## Sewer Repair and Water Valve Installation Program

### RFB ADDENDUM NO. 01

Date of Addendum: September 22, 2020

**ATTACHMENT NINE  
ENGINEERING PLAN SET**

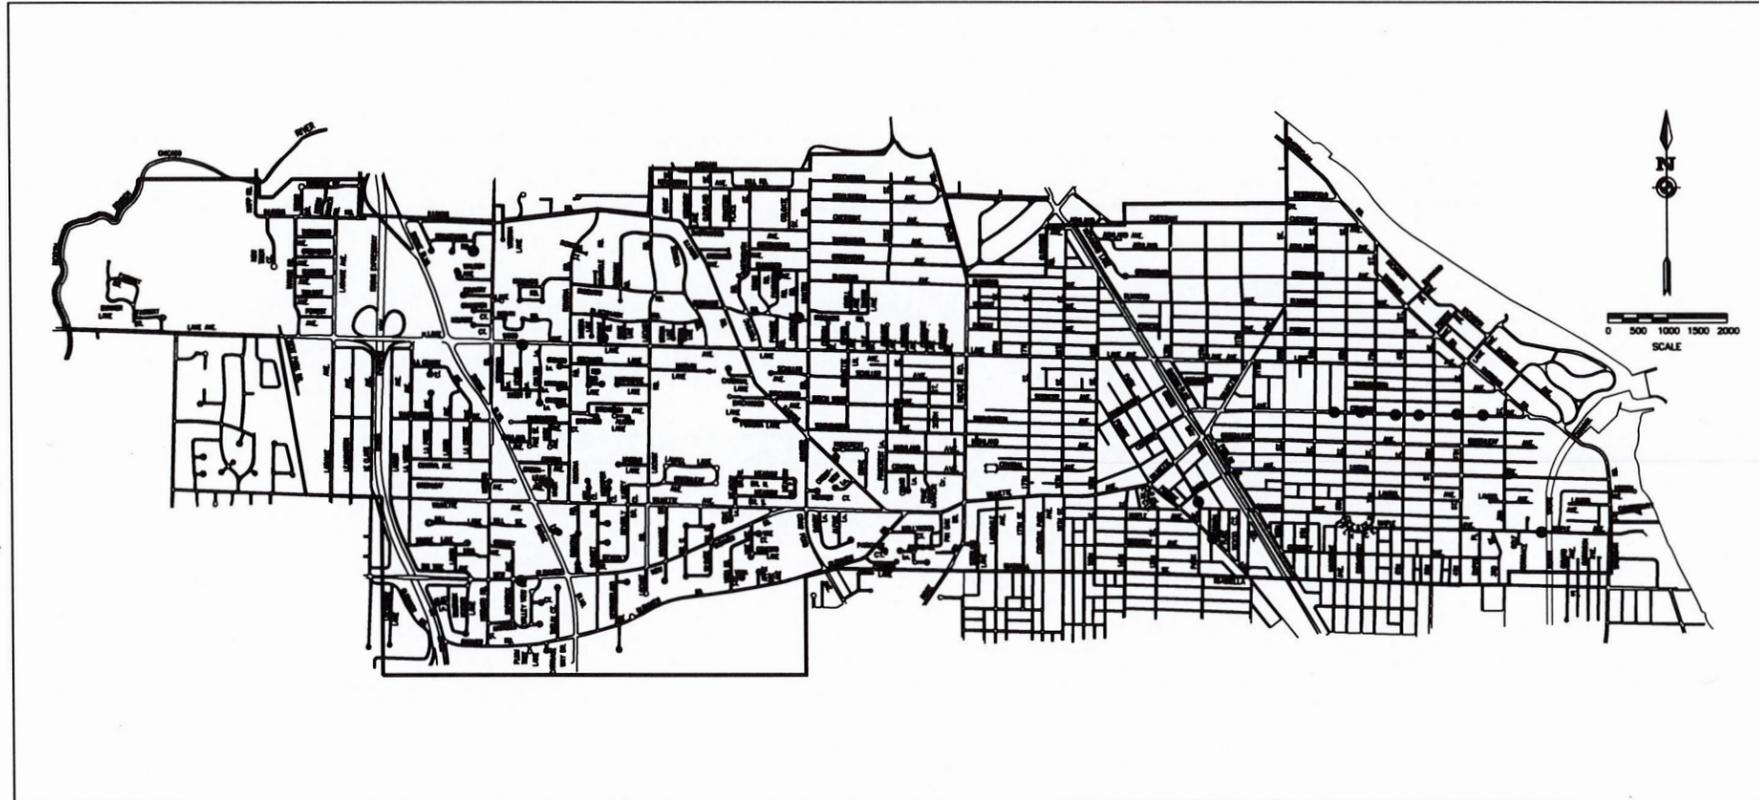
~~The project plan sets may be obtained by emailing Cliff Ruemmler, Purchasing Manager, at [purchase@wilmette.com](mailto:purchase@wilmette.com) from the Bidder's work email account.~~

Item	Section	Description of Change
2.1	Attachment Nine, page 61	The note indicating that the plan set was available via email from the Purchasing Manager has been struck. Replace the existing page 61 of the RFB with the attached page 61.
2.2	Attachment Nine	Plan set pages 61.1 to 61.22 have been added to the RFB. Insert the attached pages 61.1 to 61.22 immediately after the revised page 61 in item 2.1 above.
